# UNITED STATES PATENT AND TRADEMARK OFFICE

10/797,839

<b>Office Action Summary</b>	<b>Application No.</b> 10/797,839	<b>Applicant(s)</b> BLAKE ET AL.	
	<b>Examiner</b> Gerald W. McClain	<b>Art Unit</b> 3653

## **DETAILED ACTION**

FIG. 4

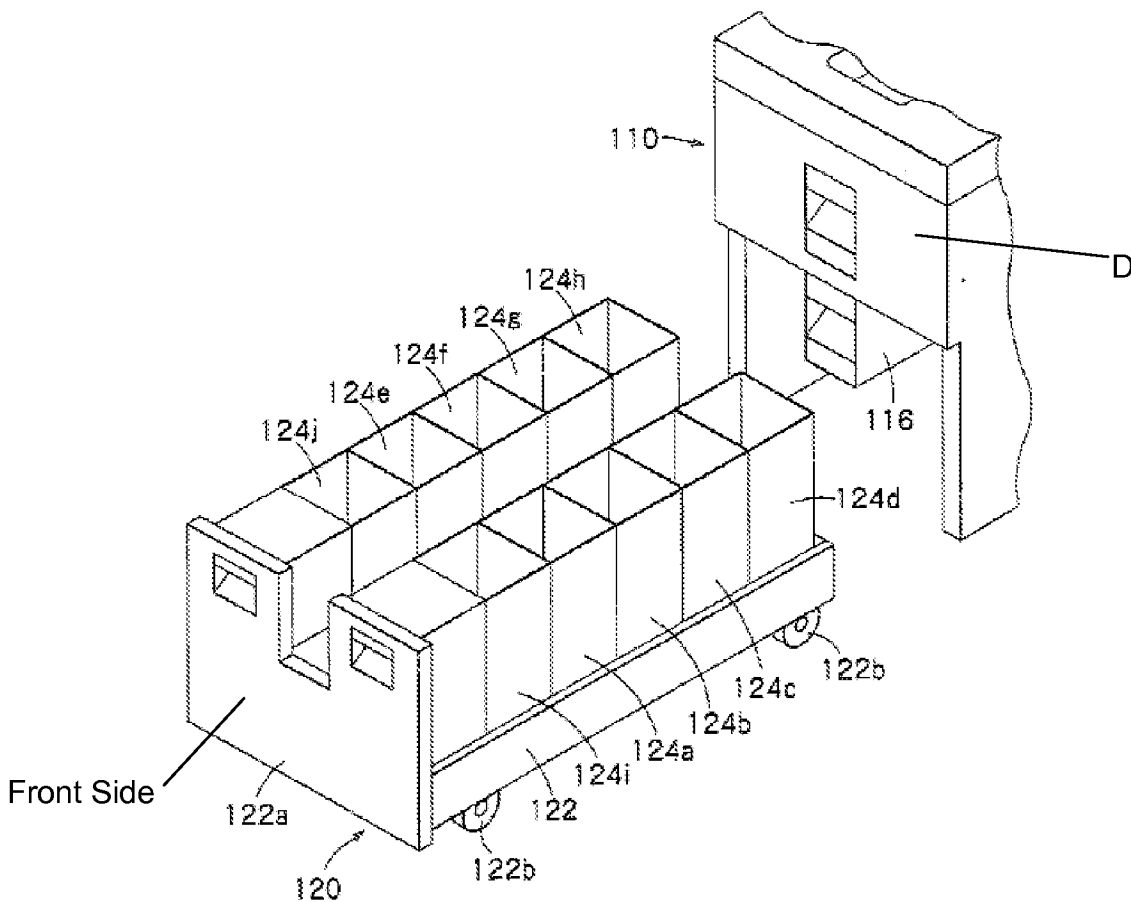
Claim 15: rear side (See FIG. 4 below, D); housing (See FIG. 2, 110);

Claim 16: front side (See FIG. 4 below, D; Note: the location of D can be defined as the rear or front side); housing (See FIG. 2, 110);

Claim 15: rear side (See FIG. 4 below, D); housing (See FIG. 2, 110);

Claim 16: front side (See FIG. 4 below, D; Note: the location of D can be defined as the rear or front side); housing (See FIG. 2, 110);

FIG. G1

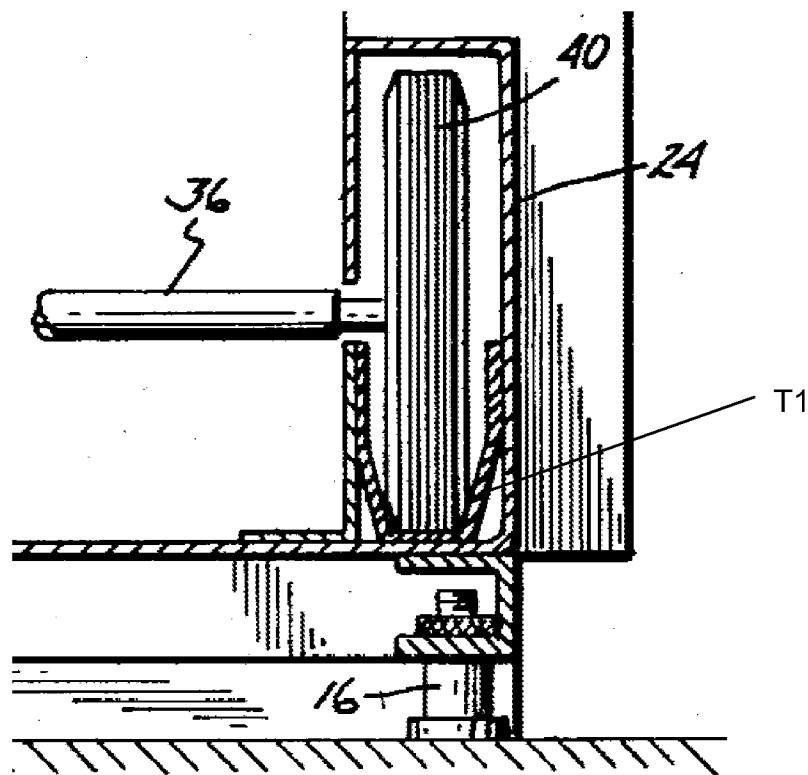
Muellner shows a similar device having a track (see FIG. G1 below, T1) for the purpose of receiving and capturing the casters (column 2, lines 57-66). Therefore, it would have been obvious to a person having ordinary skill in the art at the time the invention was made to modify Hino as taught by Muellner and include Muellner's similar device having a track for the purpose of receiving and capturing the casters.

Muellner shows a similar device having a track (see FIG. G1 below, T1) for the purpose of receiving and capturing the casters (column 2, lines 57-66). Therefore, it would have been obvious to a person having ordinary skill in the art at the time the invention was made to modify Hino as taught by Muellner and include Muellner's similar device having a track for the purpose of receiving and capturing the casters.

Muellner shows a similar device having a track (T1 above) for the purpose of receiving and capturing the casters (column 2, lines 57-66). Therefore, it would have been obvious to a person having ordinary skill in the art at the time the invention was made to modify Hino as taught by Muellner and include Muellner's similar device having a track for the purpose of receiving and capturing the casters.

Muellner shows a similar device having a track (T1 above) for the purpose of receiving and capturing the casters (column 2, lines 57-66). Therefore, it would have been obvious to a person having ordinary skill in the art at the time the invention was made to modify Hino as taught by Muellner and include Muellner's similar device having a track for the purpose of receiving and capturing the casters.
